USNRC APPLICATION
SUA-1341 License Amendment
Ludeman Project
Converse County, WY

TECHNICAL REPORT
REQUEST FOR ADDITIONAL INFORMATION
RESPONSE PACKAGE

June 2013

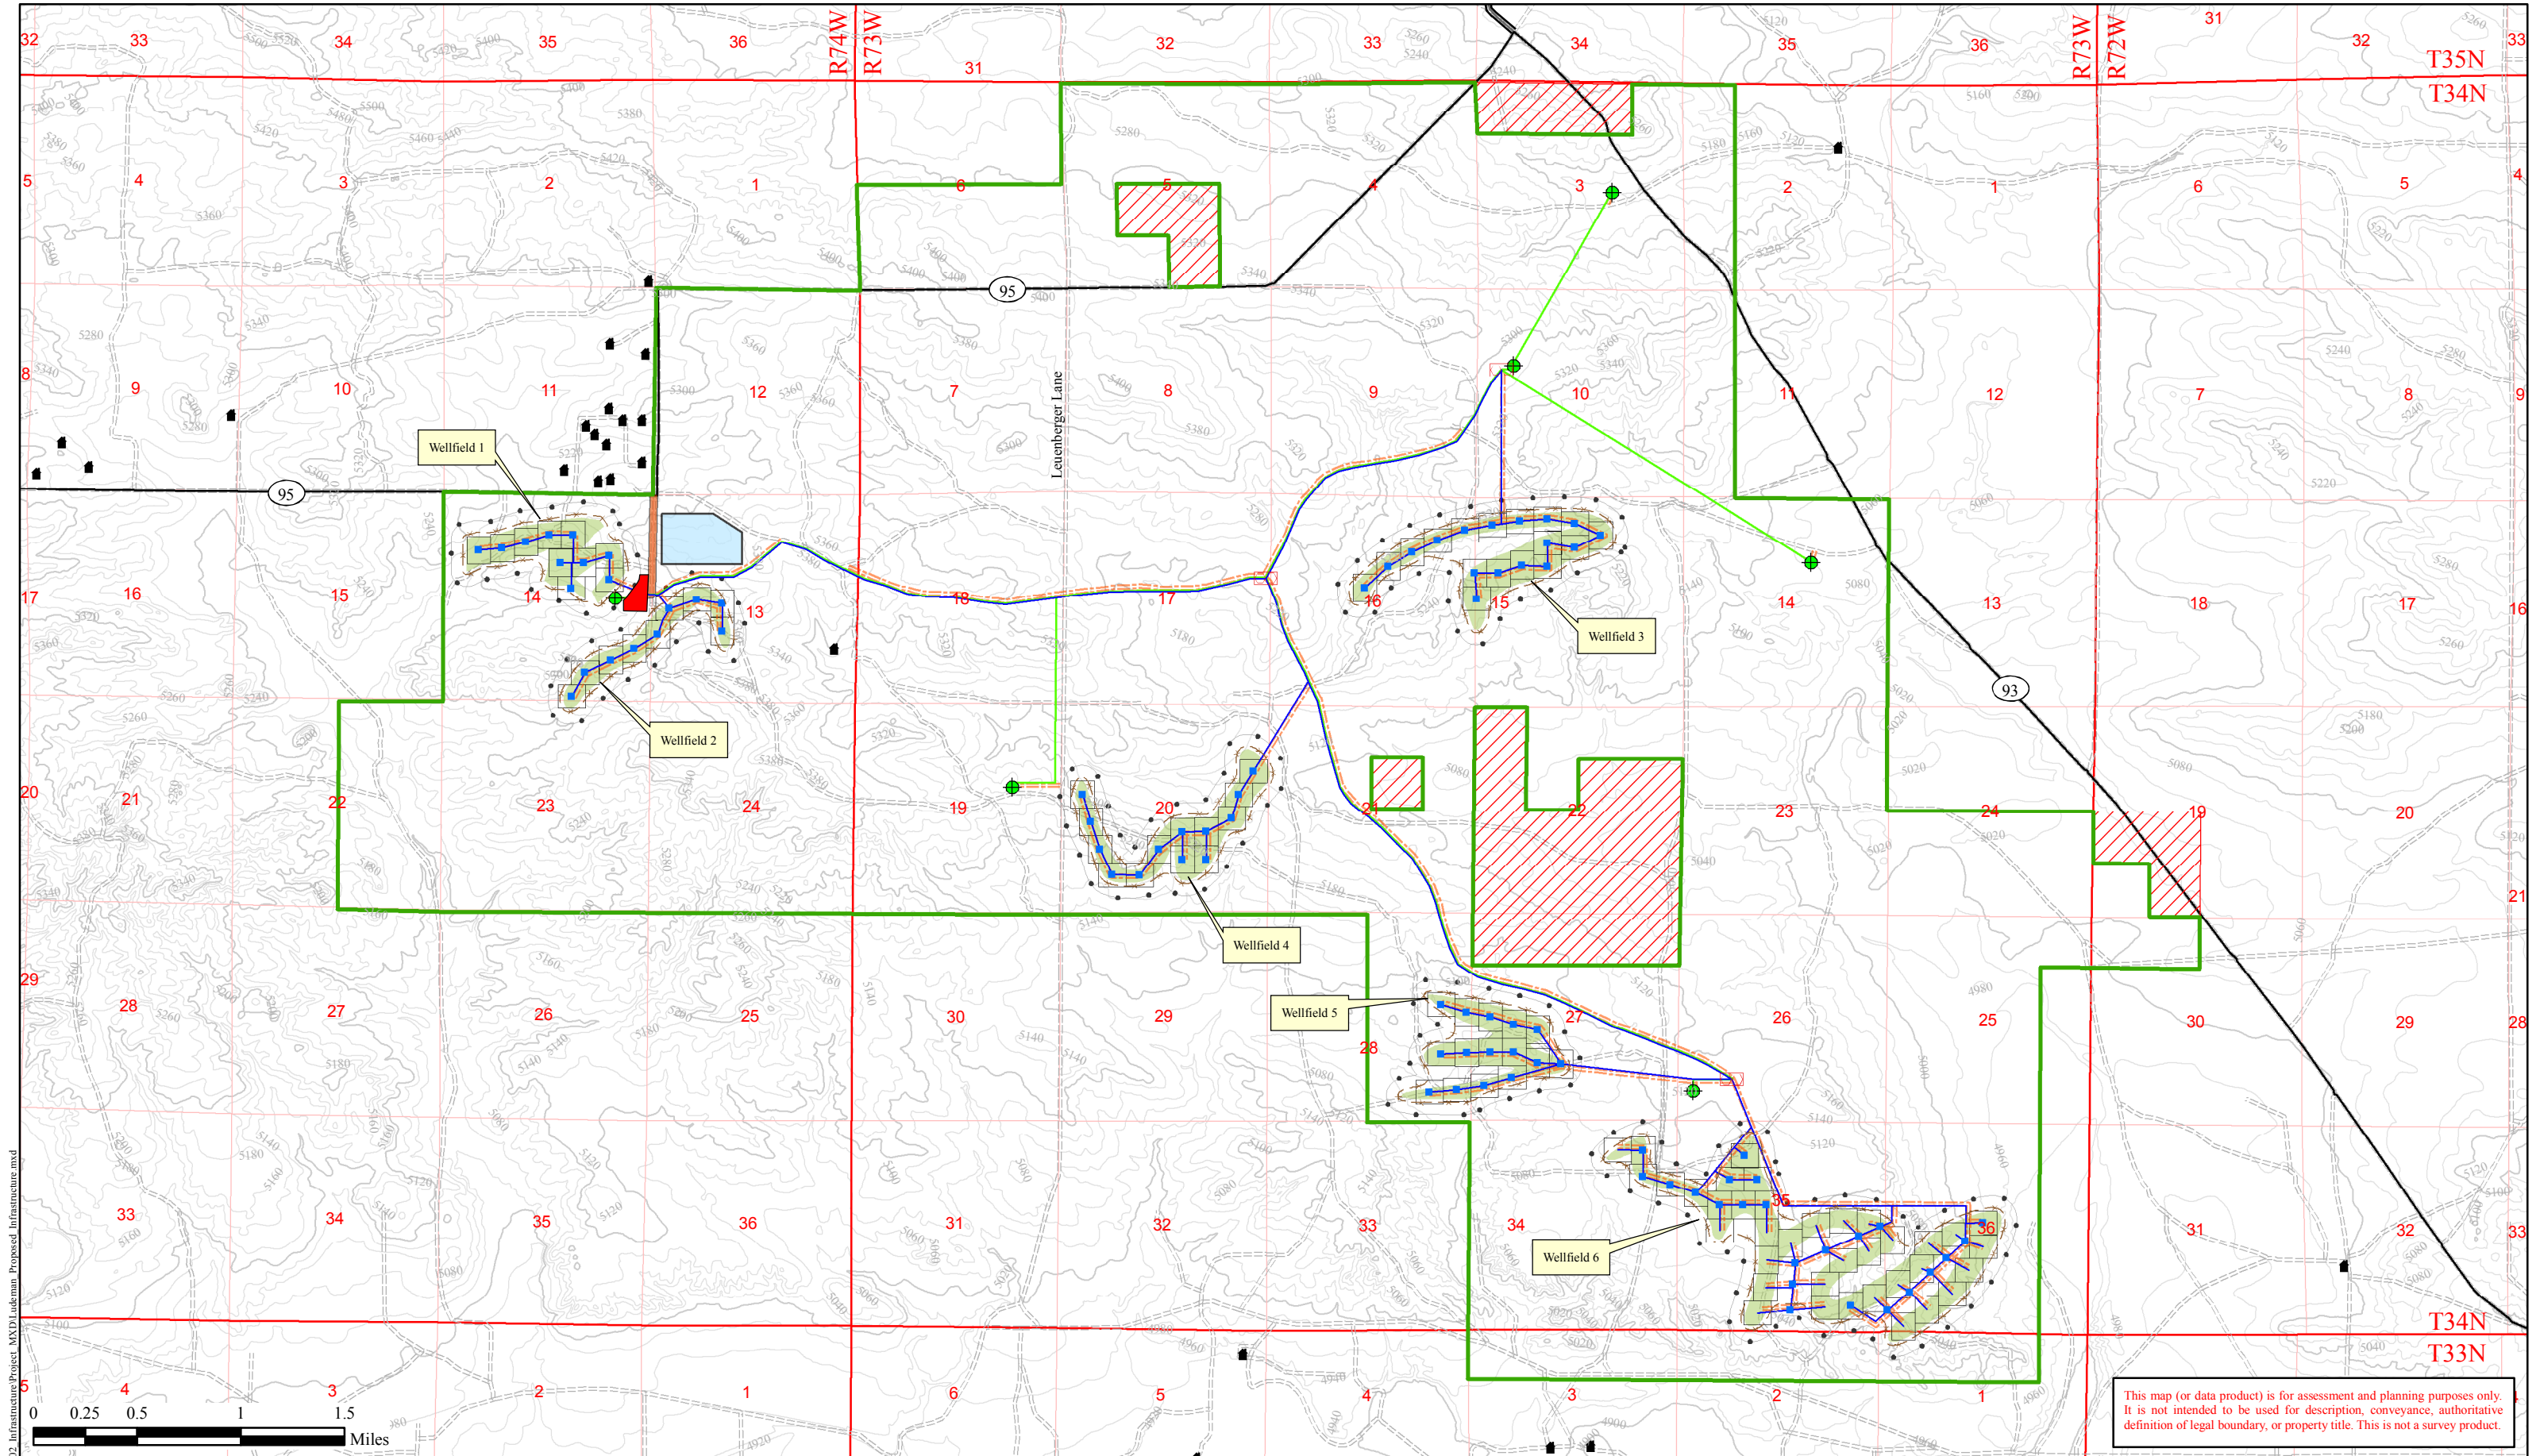
Please provide plan views of each of the proposed Satellite areas which show the baseline conditions and features for each phase of the Ludeman Project.

A. Please provide a current, baseline plan view of each of the proposed Satellite, showing each of the physical (i.e., man-made) attributes listed below:

B. Please provide a plan view of the Project areas with the same scale and size as the baseline plan view requested above and indicate each of the physical (i.e., man-made) attributes listed above for each phase (i.e., construction, operation, aquifer restoration, and decommissioning) of each of the proposed Satellite areas. Please provide these plan-view figures in an electronic format with similar features to Figure 2.1-2 in the ER, including enlargement of the Satellite areas to allow the details to be discernible. The views of the existing, current Ludeman site will serve as a baseline view and the other phased views will assist in the NRC's description of the Proposed Action and the Alternatives in Section 2 of the EA and in its evaluation of the impacts of the Ludeman Project for each phase. Specifically, comparable figures of each Satellite area are necessary to evaluate the impacts of the NRC's Alternative 3 and to compare impacts among the three Alternatives chosen by the NRC for further analysis (i.e., Alternative 1: Proposed

The existing TR Figure 2.2-2 provides the baseline plan view for all known physical attributes at the time of the initial submittal of the license application. The figure will be updated to depict the current physical attributes per the bulleted list in A. Some of the physical attributes listed should not be considered baseline features such as wellfield, header house, and planned structures outlines. These features will be depicted on the conceptual infrastructure map per RAI GEN-1(B).

The existing TR Figure 3-1 will be updated to depict the proposed project's conceptual infrastructure and other foreseen structures related to the Proposed Action. NRC's request for Uranium One to provide a plan view for all physical attributes for all phases of the project is not required under NUREG 1569 or 1748. Furthermore, this request was not required in previous Uranium One and/or other license applications that were deemed technical comprehensive and currently licensed. Uranium One believes TR Figure 2.2-2 and Figure 3-1 are adequate to assess the nature and extent of present and proposed operations for the proposed Ludeman Project. The revised infrastructure is shown below.

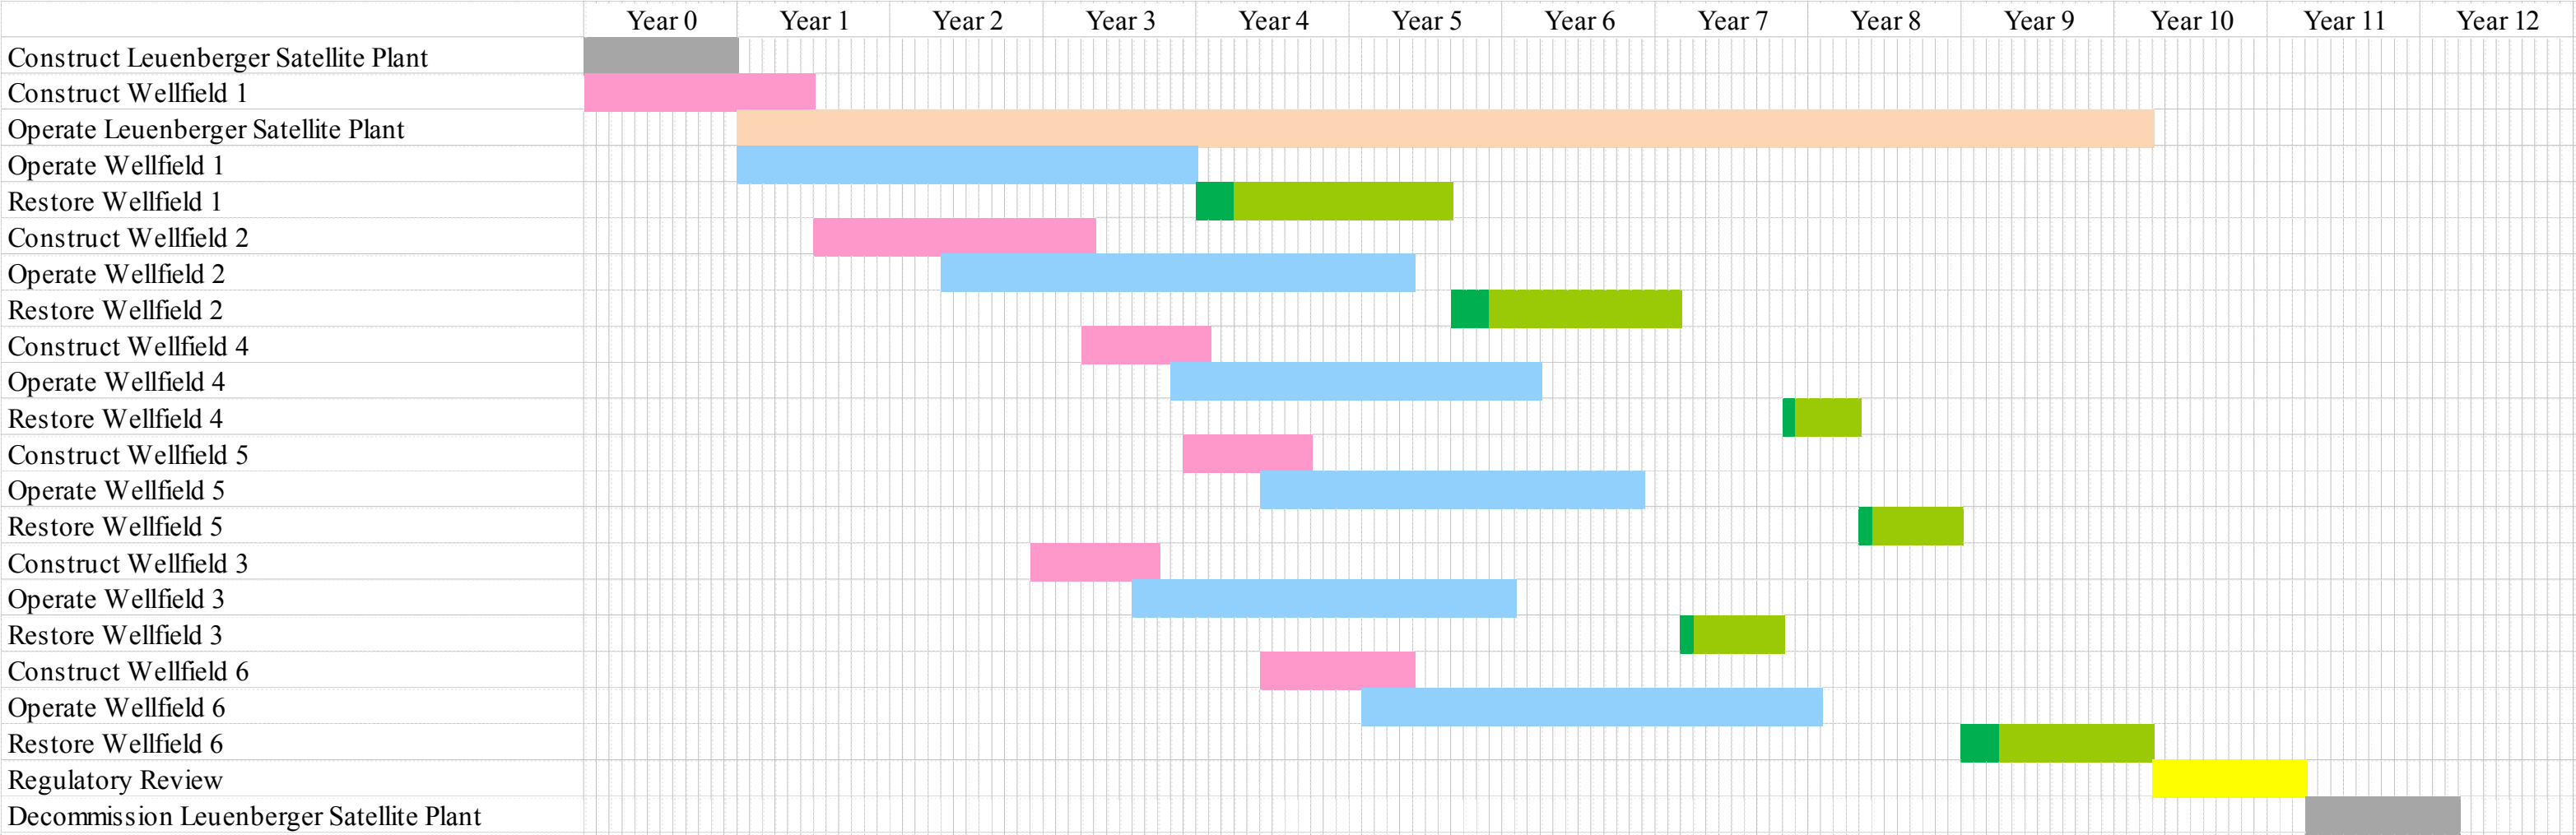
Please note any changes to the order of development of the Satellite areas that is shown in Figure 1-4 of the TR.

As a function of economics of the current and projected status of the uranium industry, Uranium One evaluated the current Ludeman Project application to assess if certain operational components of the proposed plan could be optimized. First and foremost, this evaluation identified the utilization of a single satellite plant as opposed to the three satellites proposed in the original application. A single satellite plant has been deemed more economically feasible and would diminish a number of potential impacts. It is Uranium One's strong opinion this modification will improve the viability of the project and overall reduce any potential impacts.

A revised schedule illustrating the construction, production, restoration and decommissioning phases of the proposed project will replace the original schedule in all applicable sections of the application. The revised conceptual schedule is shown on the following page.
